Addendum (ADD) #01

| Project: | 20-602: Marshfield Early Childhood Center |
| Client: | Marshfield R-I School District |
| Date: | June 15, 2021 |

A8-0 MARSHFIELD EARLY CHILDHOOD CENTER
 REFLECTED CEILING PLAN - AREA A
 PROJECT NUMBER: 20-602
 PROJECT DESCRIPTION: 600 N Locust St, Marshfield, MO 65706
 PROJECT ARCHITECT: BEE
 DRAWN BY: CS, KMW
 CHECKED BY: KMW, PY
 DATE: 2021.06.09

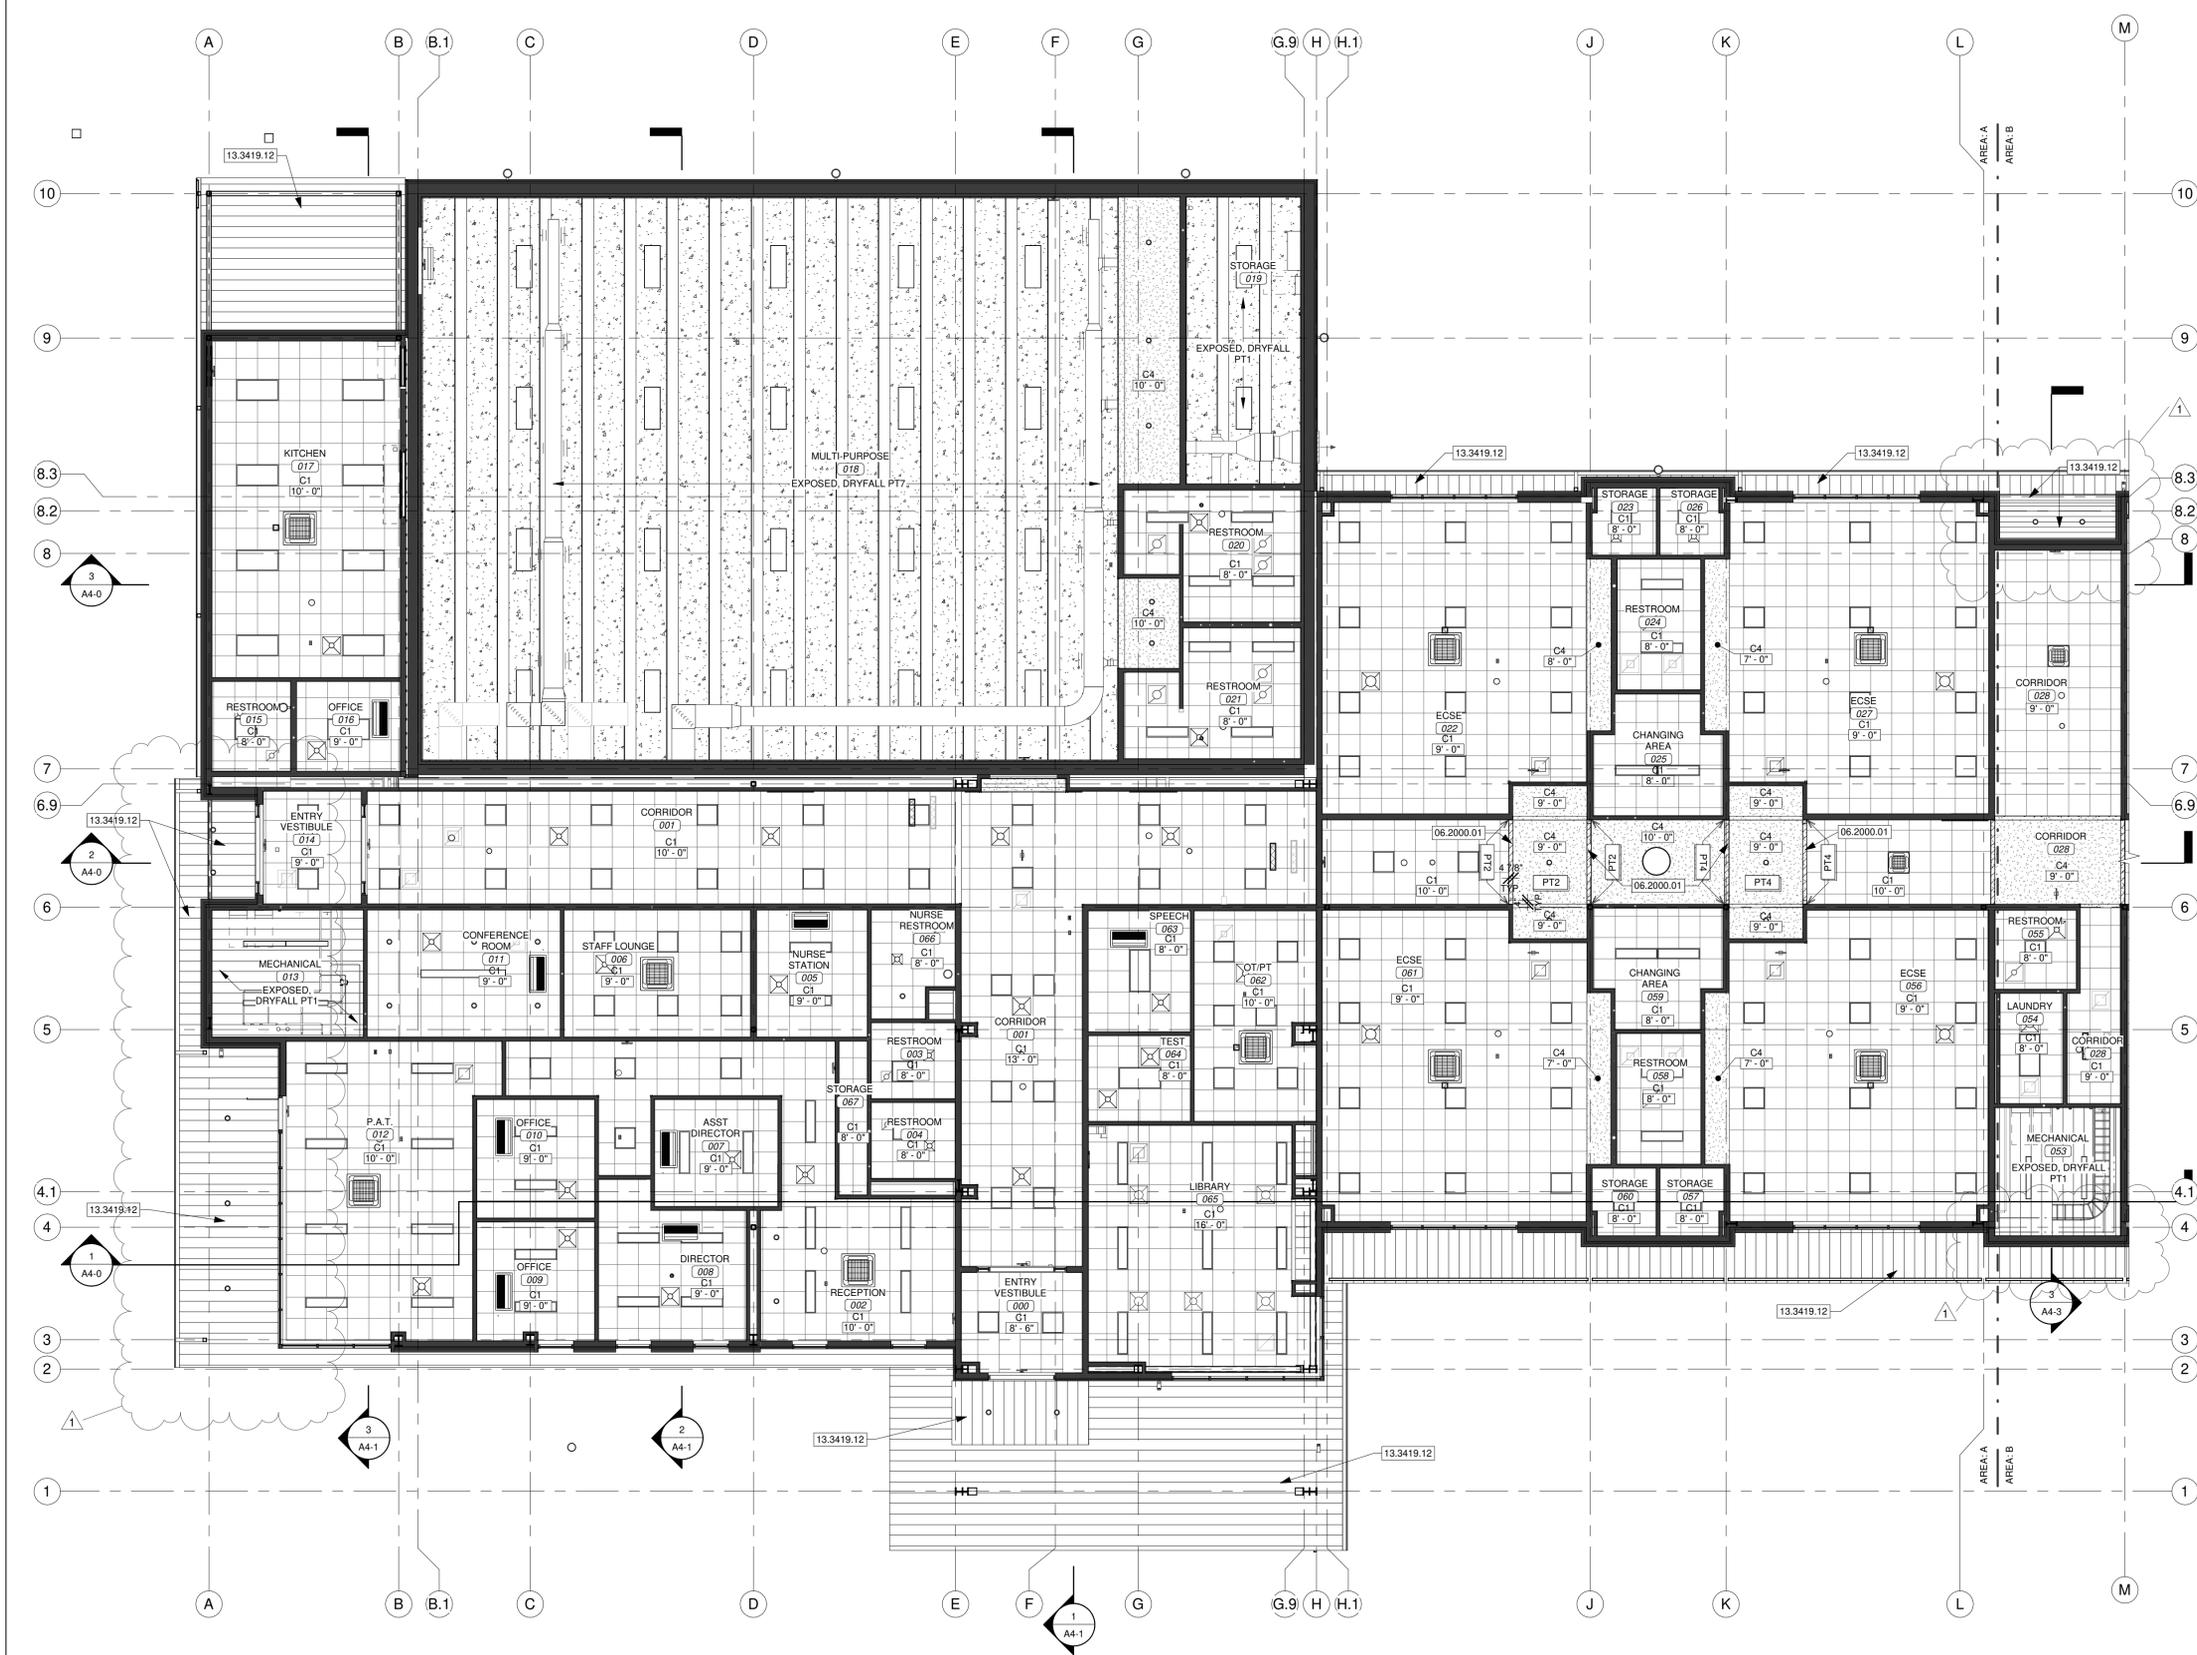
- a. Revise, Detail 1
 - i. Building footprint adjustments at Corridor 028 and Mechanical 053.
 - ii. Building overhang adjustments.
- 13. *Sheet A8-1 – Reflected Ceiling Plan – Area B:*
 - a. Revise, Detail 1
 - i. Building footprint adjustments at north exterior walls and south exterior walls.
 - ii. Building overhang adjustments.
- 14. *Sheet A9-0 – Finish Plan – Area A:*
 - a. Revise, Detail 1
 - i. Building footprint adjustments at Corridor 028 and Mechanical 053.
 - ii. Building overhang adjustments.
- 15. *Sheet A9-1 – Finish Plan – Area B:*
 - a. Revise, Detail 1
 - i. Building footprint adjustments at north exterior walls and south exterior walls.
 - ii. Building overhang adjustments.
- 16. *Consultant Drawings:*
 - a. Revise
 - i. Civil, Structural and MEP Drawings
 - 1. Please see attached.

PROJECT DESCRIPTION:
E1 MARSHFIELD ECC AREA 'A' LIGHTING PLAN

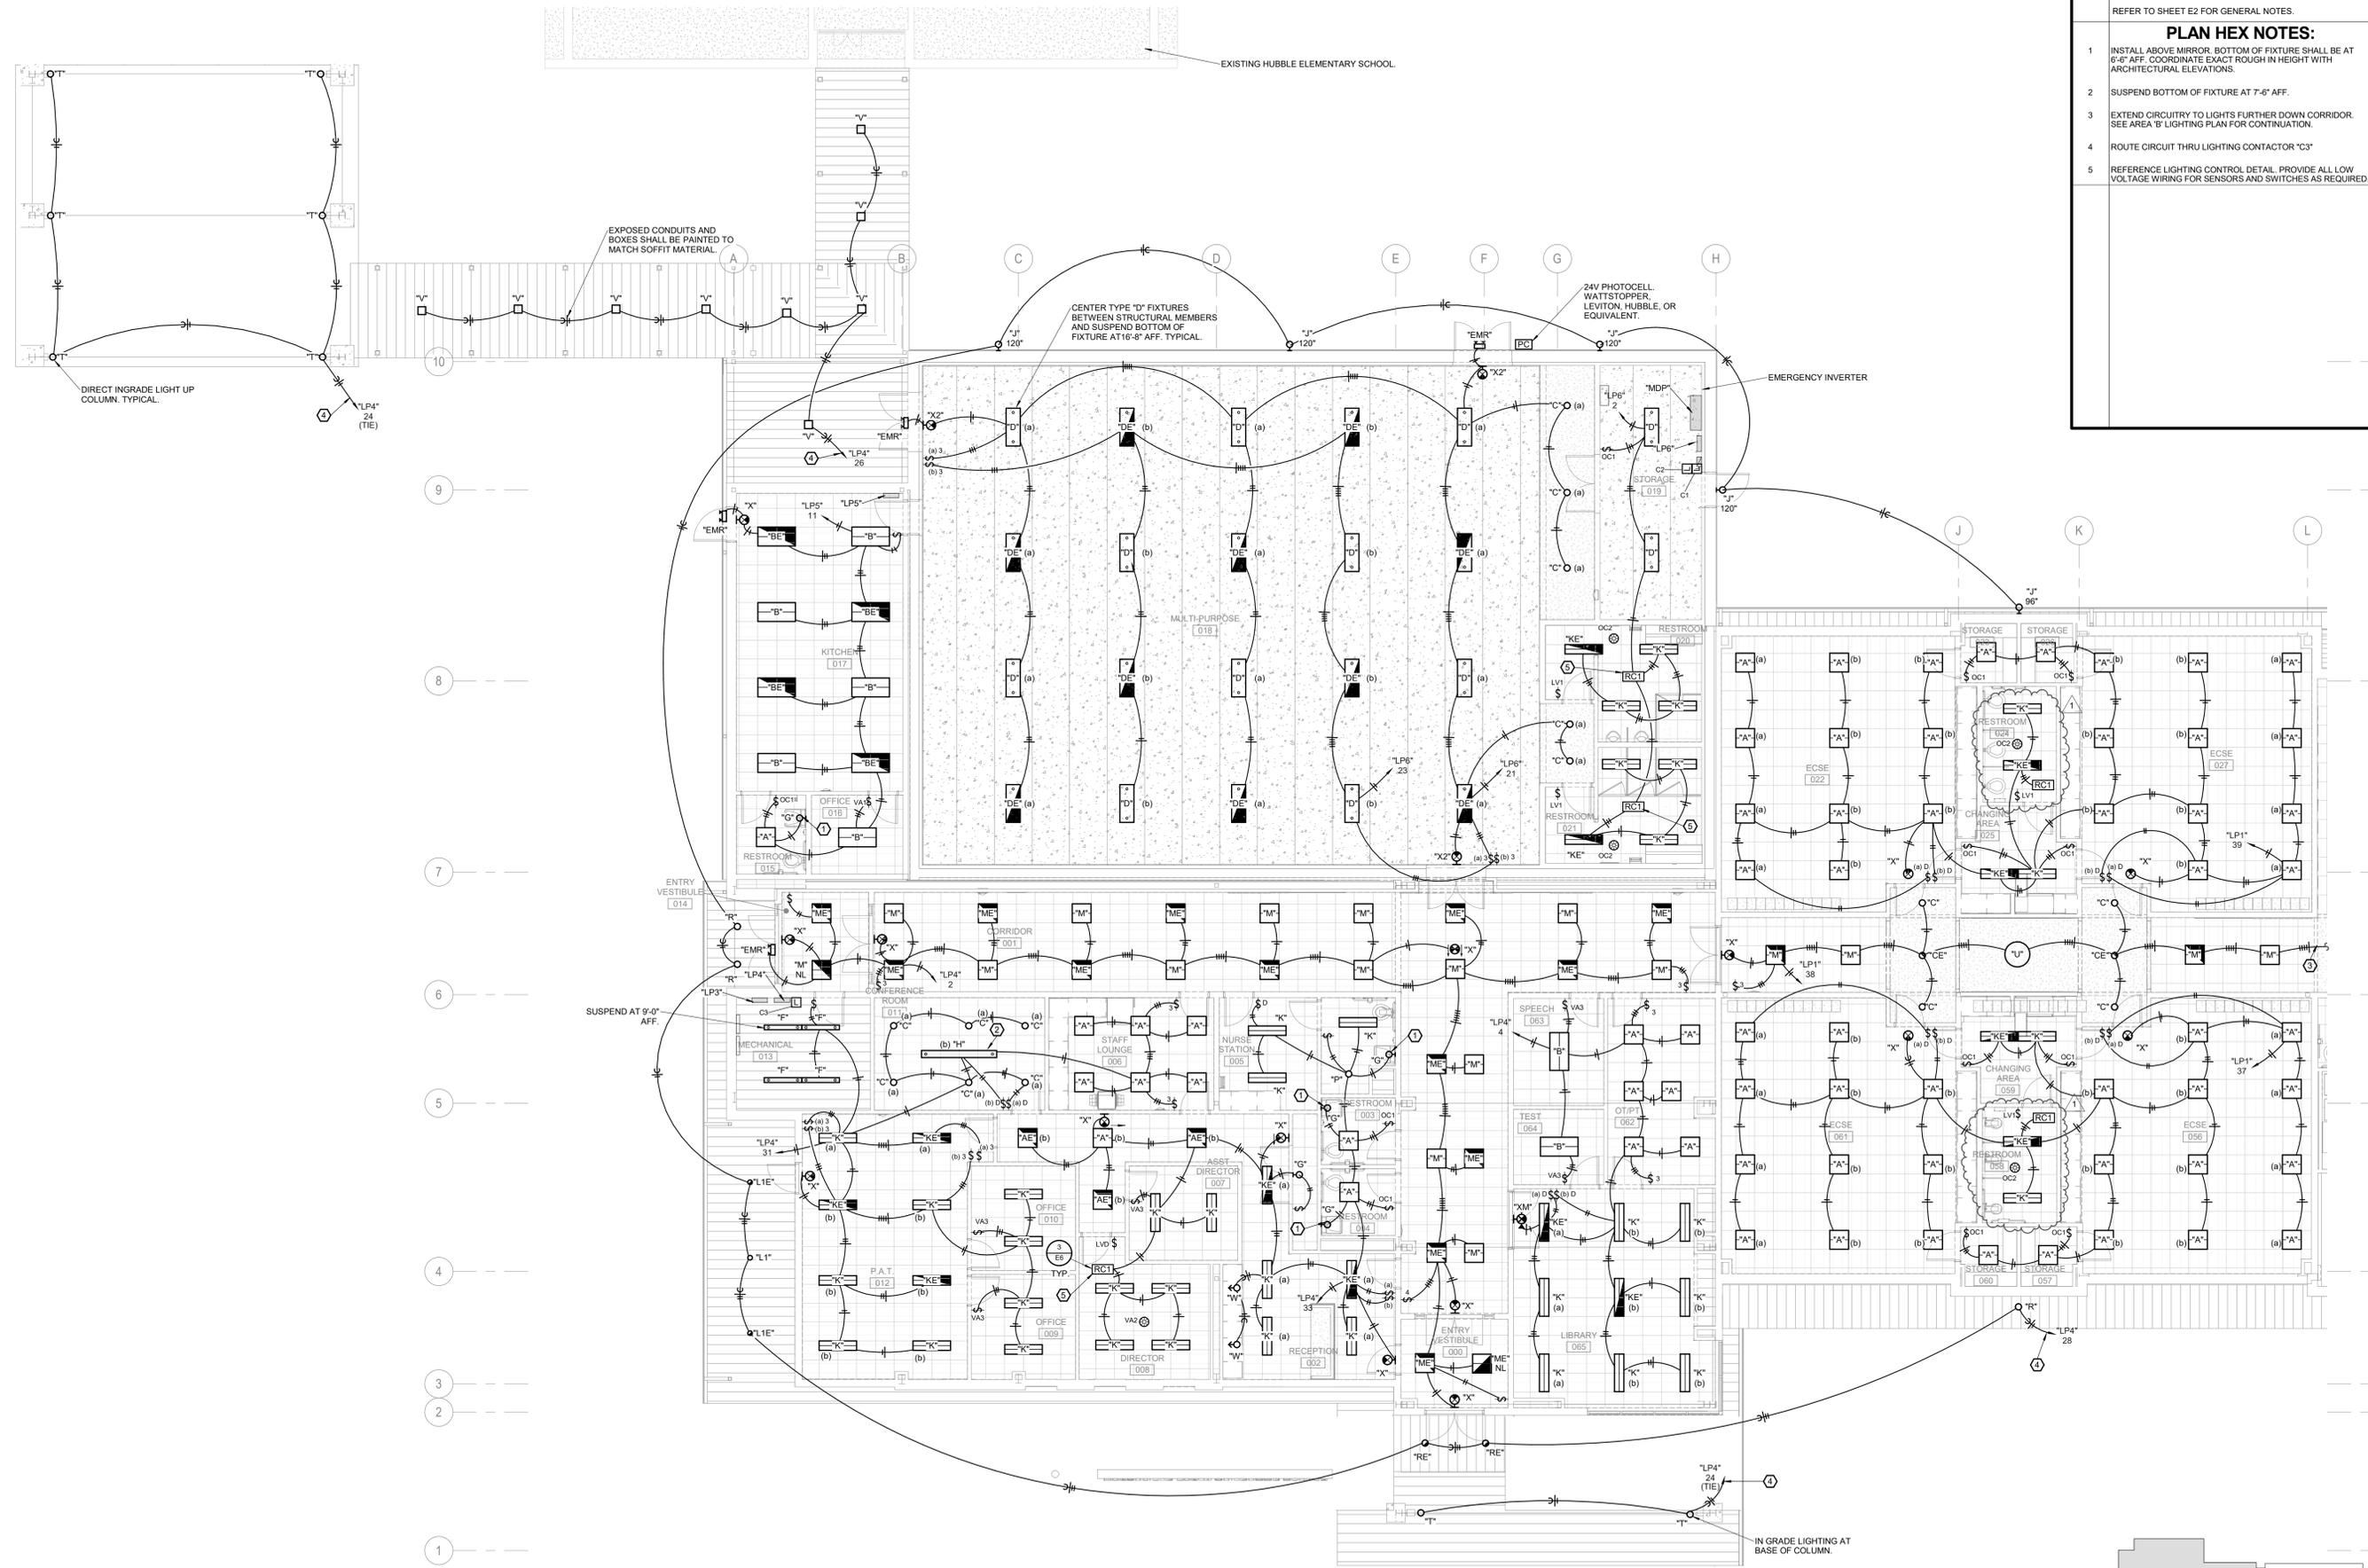
- 1. Reference Sheet E1, "Area 'A' Lighting Plan, 1/E1":
 - a. See revised full size sheet for changes to the lighting controls in restrooms 021 and 058.
- 2. Reference Sheet E2, "Area 'B' Lighting Plan, 1/E2":
 - a. Full size sheet re-issued for revised building footprint.
 - b. See revised full size sheet for changes to the restroom lighting and controls.
- 3. Reference Sheet M4, "Area 'B' Power Plan, 1/E4":
 - a. Full size sheet re-issued for revised building footprint.
 - b. Omit receptacle shown in restroom 049.
 - c. Cable tray from main IT room shall be 18"x4".
